REMARKS

THE SPECIFICATION

THE DRAWINGS

FIG 6

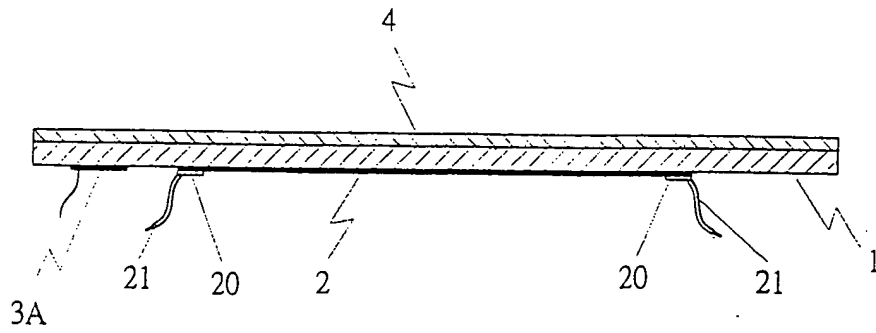
The Office Action indicated that “the water tank on the heating plate, the sensing electrode provided under the heating plate, the water level sensor and temperature fuse provided under the heating plate, must shown or the feature(s) canceled from the claim(s).”

In response, Applicant has amended Figs. 7 and 8 to show the water tank on the heating plate, and amended Figs. 5 and 6 to show the water level sensor and temperature fuse provided under the heating plate. The specification has also been amended accordingly.

FIG 8

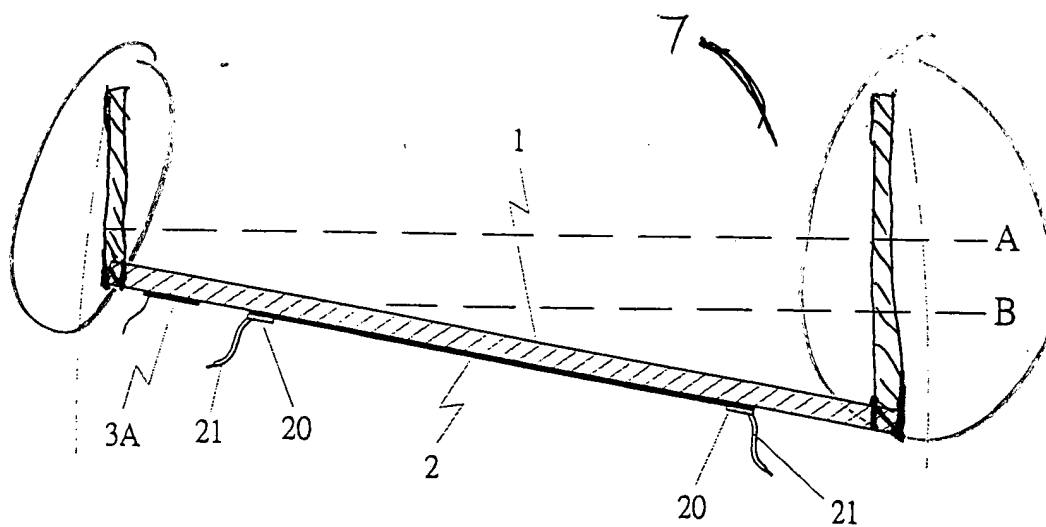
“[T]he sensing electrode provided under the heating plate” is shown in Figs. 3 and 8 (see the element 3A).
